SNO-ISLE LIBRARIES

IFB 2024.08.29LAK Lake Stevens Library

Project ADDENDUM # 7: Questions, Answers, and Substitution Request Responses

October 4, 2024

SECTION - TYP STAIR 1 TREAD

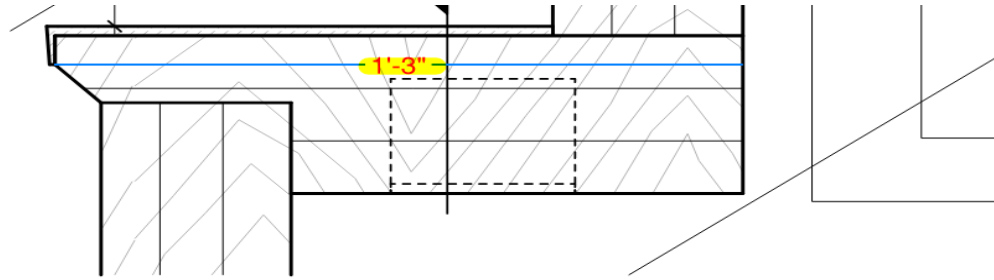
- Please confirm the interior glass ID's 103, 105, and 107 are required to be Low E.
Low E not required on interior glazing
- In the review of the CLT stair details, we are concerned with the layout used in detail 1 A501. We intend on pricing a GLT stair tread. Is that acceptable?
CLT stair tread must be used. Detailing can be discussed during shop drawings.
- Please confirm the riser material as Solid blocking, CLT or GLT?
Treads and risers are to be 3-ply CLT as shown in 1/A501.
- There is a discrepancy in the drawing for what the actual tread depth is, can you please confirm?
Dimensions are as shown on 1/A501.

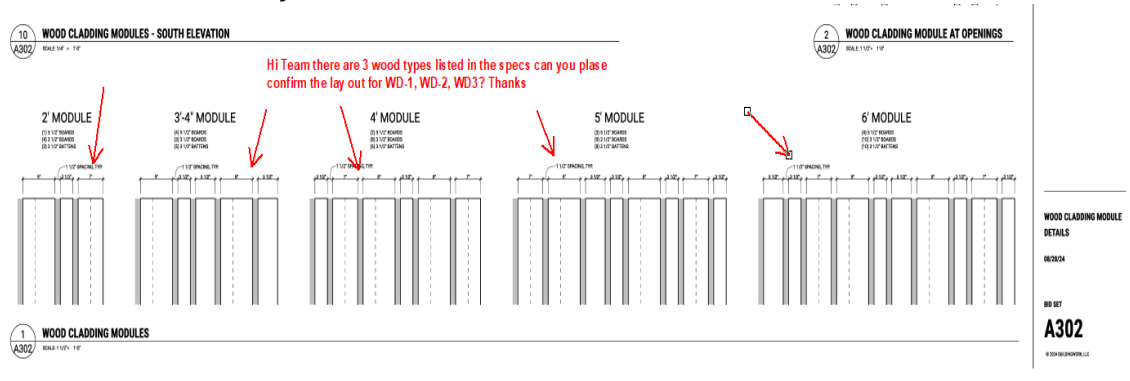
- **Drawing sheet S101** specifies QTY (4) glulam beams as “FR1” which we interpret as 1-hour fire rating.

Are these the only four glulams that need a 1-hour fire rating modified layup, or do all the glulams in the project need a 1-hour fire rating modified layup?

Yes. Note updated drawings added another FR-1 glulam in the same vicinity.

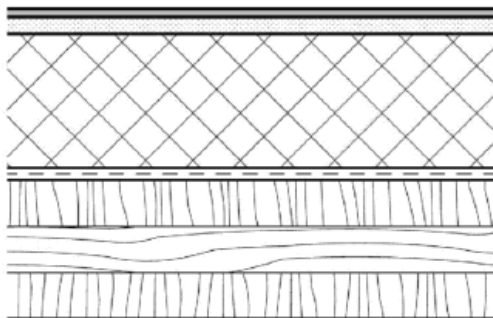
- Could you please help identify the electrical vaults.

Refer to revised sheet E101 issued in Addendum 5.

R1 CLT ROOF ASSEMBLY

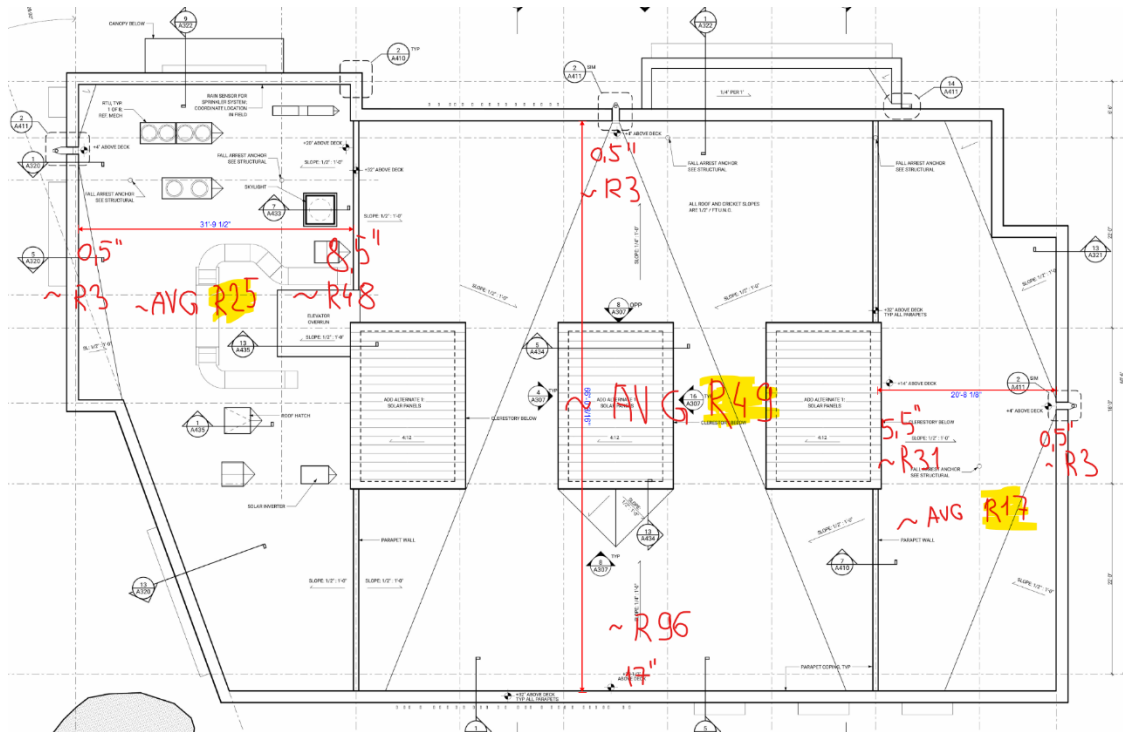
- The roof insulation is considered to be done with tapered rigid insulation (ISO with R-5.7 per inch): How to calculate base layer of the foam to meet requirements in the plan (A401 R1):

This approach having averaged R-value=38 leaves roof with some significant areas with R-value less than R-38:

Minimum base layer of foam insulation at any location to be 4". See calculated heights of insulation above deck on roof plan; architect has confirmed overall average of R-38.

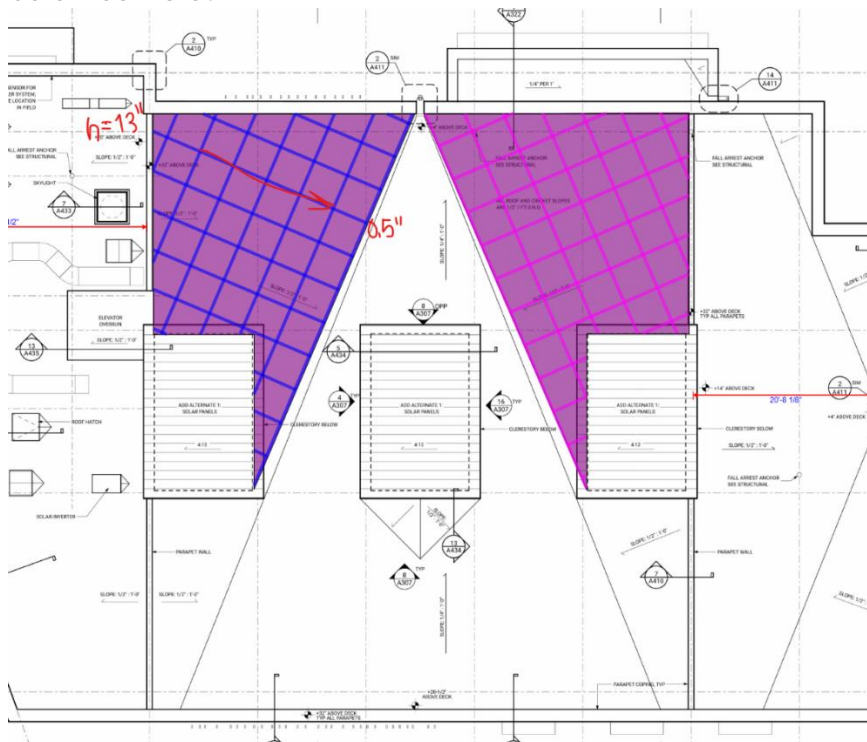
- Is the cricket schema on the main roof done to provide better R-value in the marked below corners?

Layout schema is to direct water to single downspout as noted on plans. During submittal process, shop drawings may propose alternate solutions that achieve average R-value and do not add any downspouts, for design team consideration. All bidders to price layout as shown in contract documents.
